CEDAR BROOKE
SUBDIVISION OBSERVATION REPORT

July 25, 2012

HR GREEN JOB NO. 86120056

Cedar Brooke Subdivision Observation Report

CEDAR BROOKE
 LOT 31

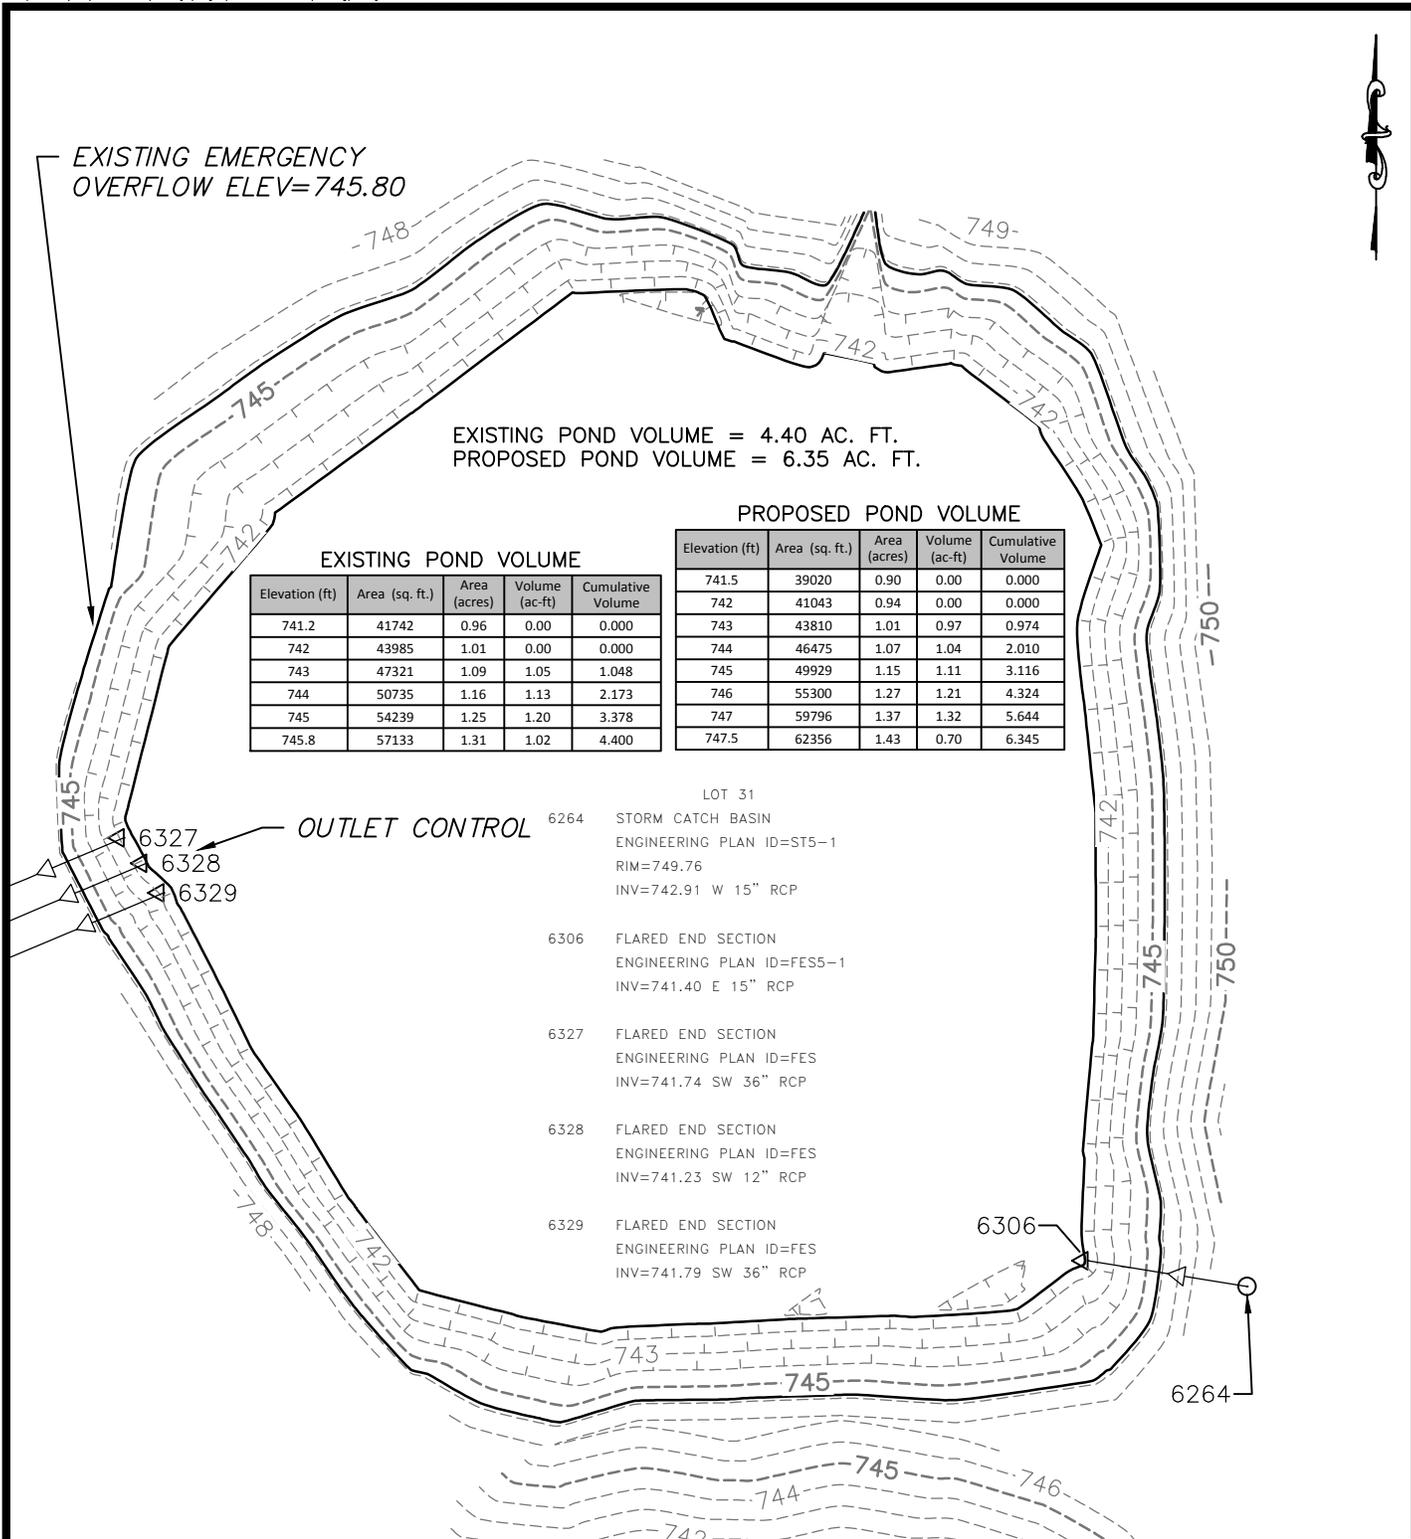
POND A (LOT 31)			
	PROPOSED	EXISTING	DIFFERENCE
NWL	741.50	741.20	0.30' LOW
HWL	747.50	745.80	1.70' LOW
STORAGE VOLUME (AC.FT.)	6.35	4.40	1.95 Shortage

The restrictor pipes were all constructed an average of 0.27' low. The 100-year emergency overflow was constructed 1.7' lower than the proposed elevation. This results in a reduced storage volume for the basin. This basin does not comply with the design plans. A detailed review of the original drainage calculations or a hydraulic analysis would be required to determine the impact of these deviations.

CEDAR BROOKE
 LOT 33

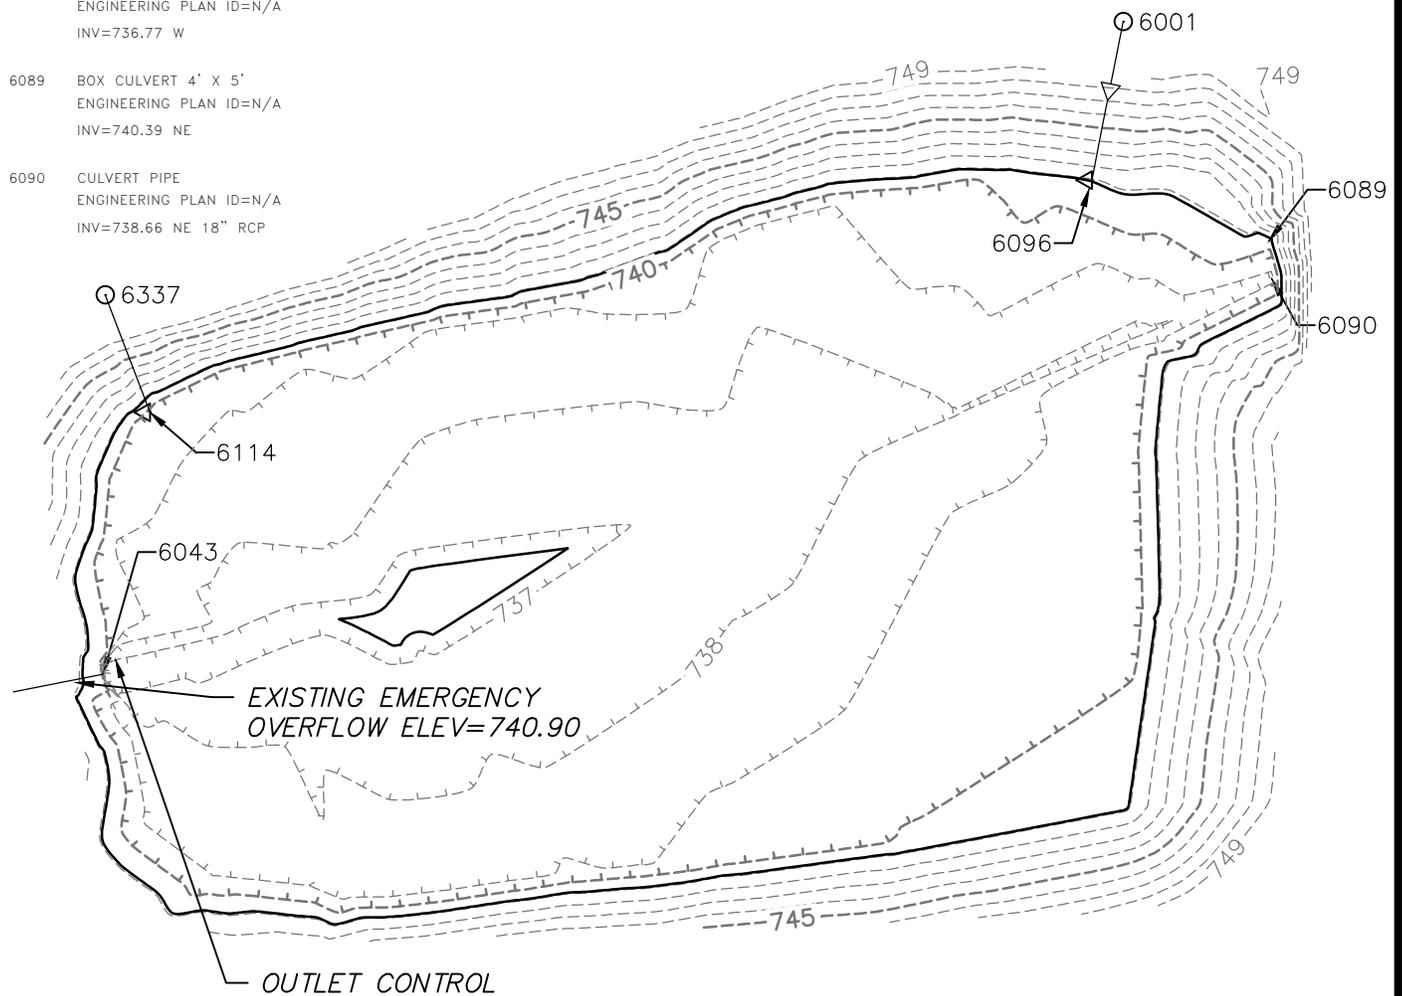
POND B (LOT 33)			
	PROPOSED	EXISTING	DIFFERENCE
NWL	739.00	739.00	ASSUMED EQUAL
HWL	741.50	740.90	0.60' LOW
STORAGE VOLUME (AC.FT.)	4.22	2.96	1.26 Shortage

The outflow pipe was constructed 0.13' low which is within an acceptable construction tolerance. This outfall is below the NML elevation of 739.00 stated on the plans so it is assumed that the creek has an existing NWL at the same elevation. The 100-year emergency overflow was constructed 0.6' lower than the proposed elevation. This results in a reduced storage volume for the basin. This basin does not comply with the design plans. A detailed review of the original drainage calculations or a hydraulic analysis would be required to determine the impact of these deviations.

EXISTING POND VOLUME = 2.96 AC. FT.
 PROPOSED POND VOLUME = 4.22 AC. FT.

LOT 34 NORTH

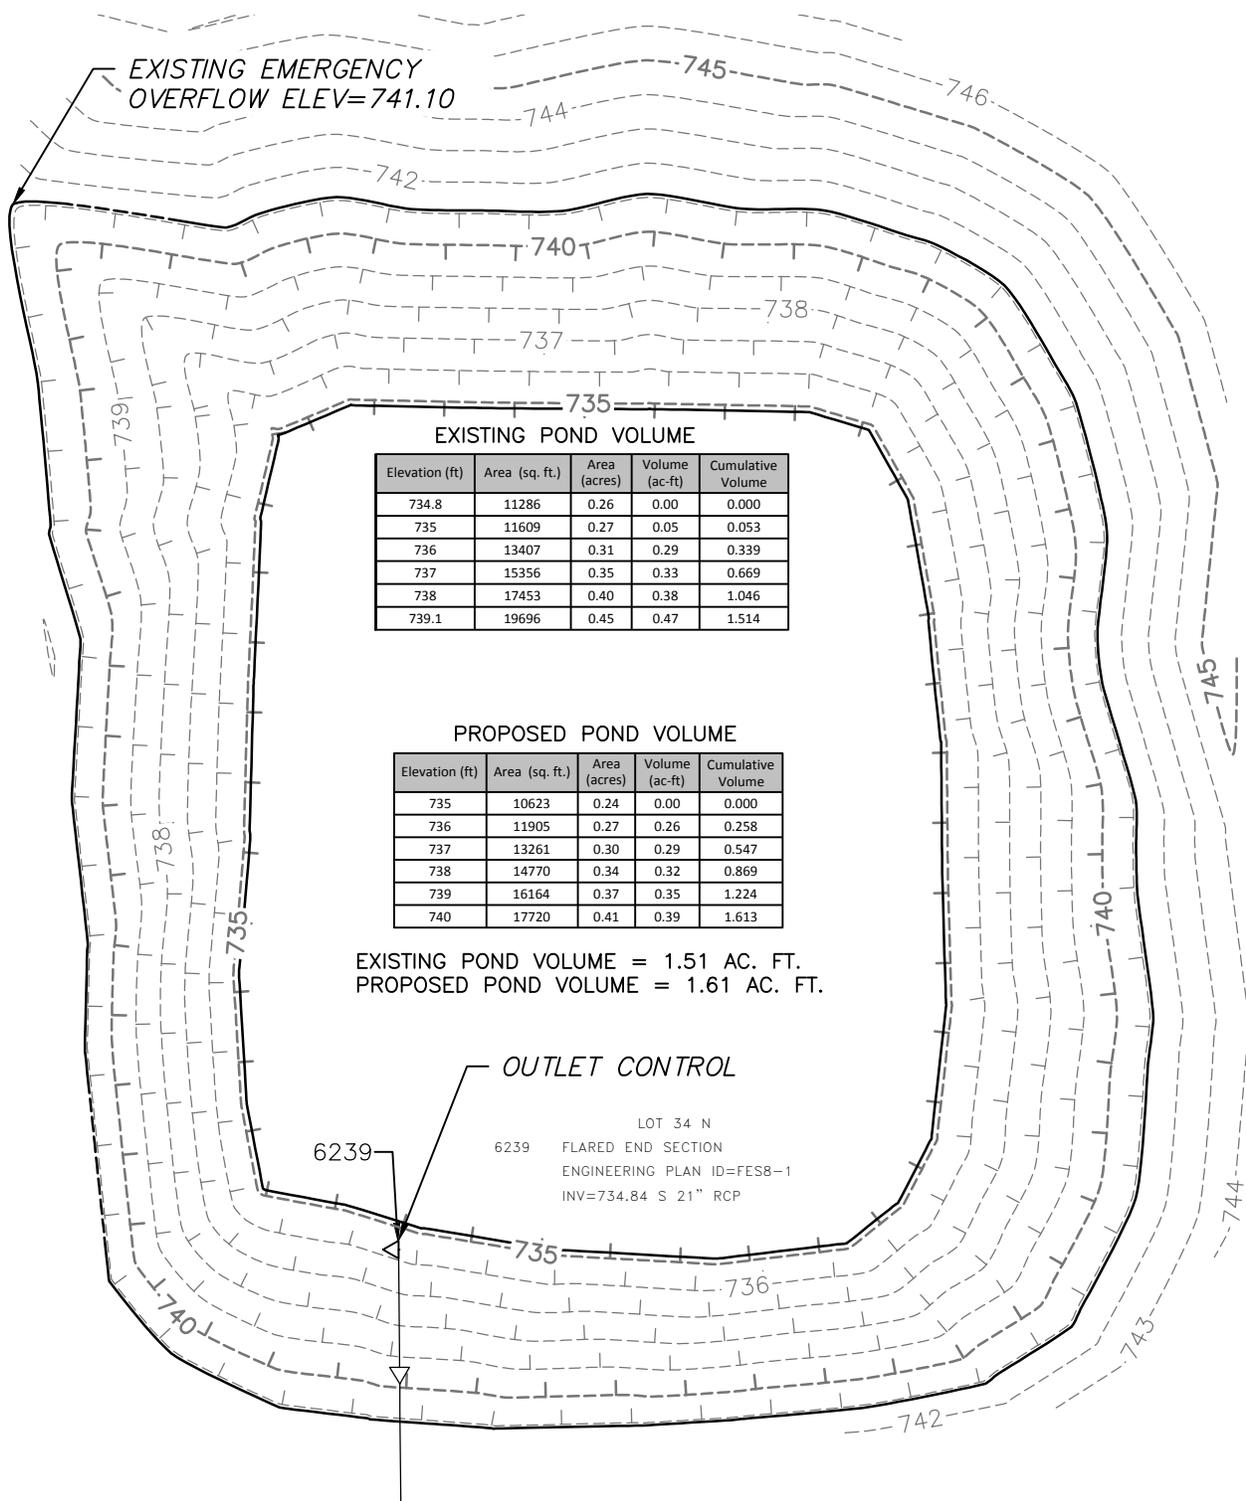
POND C (LOT 34 NORTH)			
	PROPOSED	EXISTING	DIFFERENCE
NWL	735.00	734.80	0.20' LOW
HWL	740.00	739.10	0.90' LOW
STORAGE VOLUME (AC.FT.)	1.61	1.51	0.10 Shortage

The outflow equalizer pipe was constructed 0.16' low which is within an acceptable construction tolerance. This pond did not have a designed emergency overflow weir. For this analysis we have assumed it to be the top of berm at an elevation of 742.00. The existing overflow elevation was determined to be 741.10, 0.9' lower than proposed. This does not affect the storage volume of the basin because it is interconnected to Pond D which controls the ultimate HWL and overflow for both basins. The Pond D was overflow constructed 1.1' low which results in a reduction to the storage volume. This basin does not comply with the design plans.

CEDAR BROOKE
 LOT 34 SOUTH

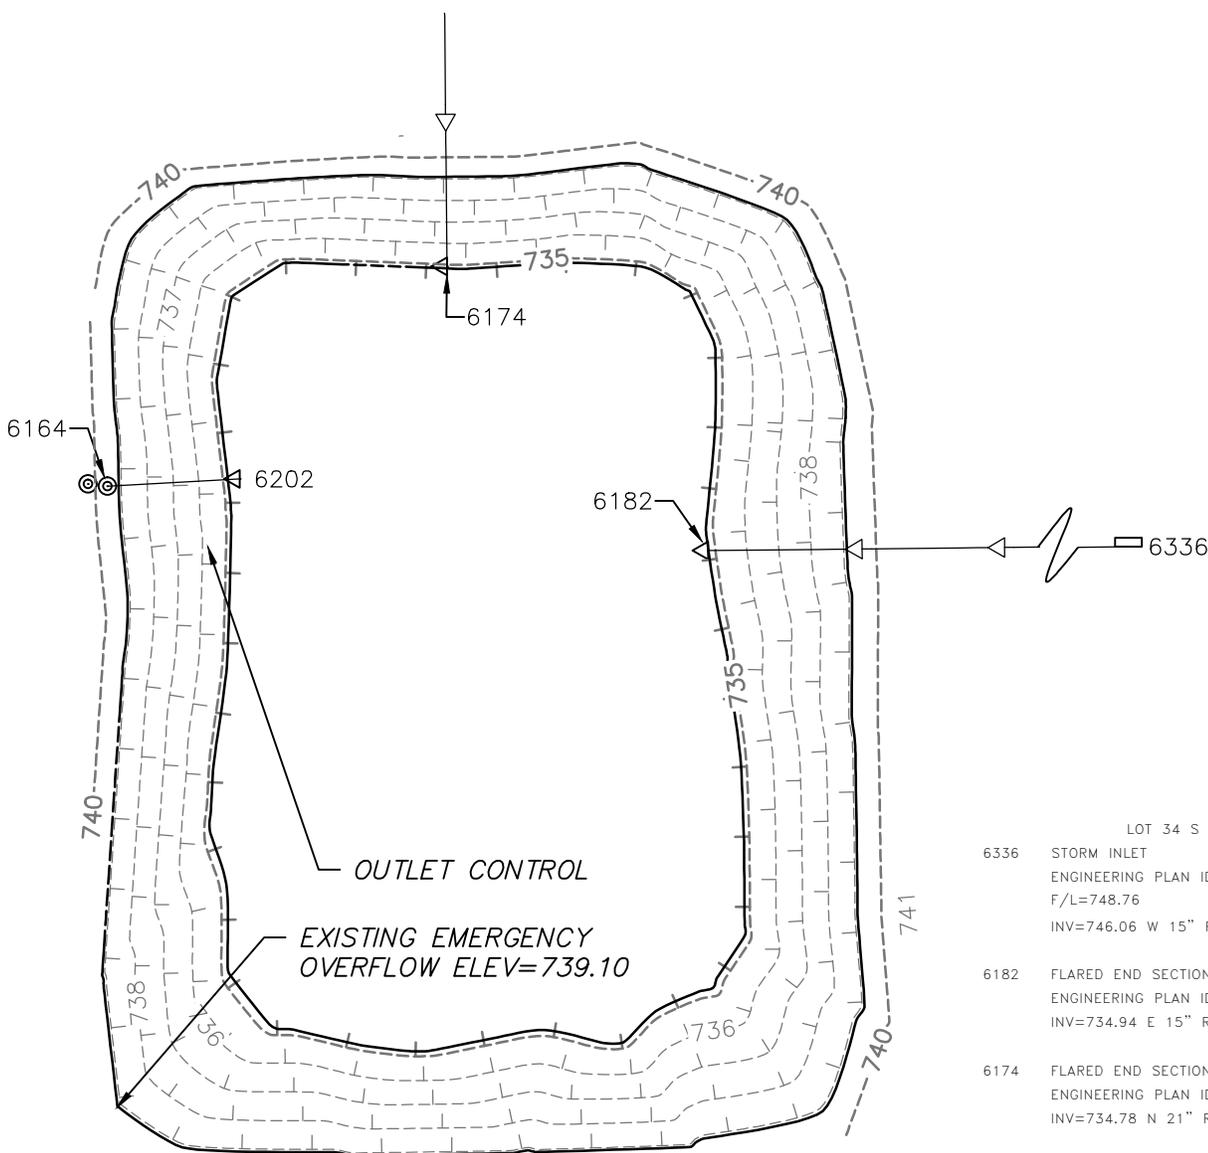
POND D (LOT 34 SOUTH)			
	PROPOSED	EXISTING	DIFFERENCE
NWL	735.00	734.80	0.20' LOW
HWL	740.00	739.10	0.90' LOW
STORAGE VOLUME (AC.FT.)	1.12	1.07	0.05 Shortage

In Pond D the diameter of the 2 year restrictor orifice was constructed 0.5" larger than was proposed. The 100-year restrictor orifice was constructed 0.2" larger than was proposed. These deviations would result in a stormwater release rate that is greater than the rate proposed. Both The 100-year emergency overflow and the weir wall were constructed lower than their proposed elevations. This results in a reduced storage volume for both basin C and D. This basin does not comply with the design plans. A detailed review of the original drainage calculations or a hydraulic analysis would be required to determine the impact of these deviations

EXISTING POND VOLUME = 1.07 AC. FT.
 PROPOSED POND VOLUME = 1.12 AC. FT.
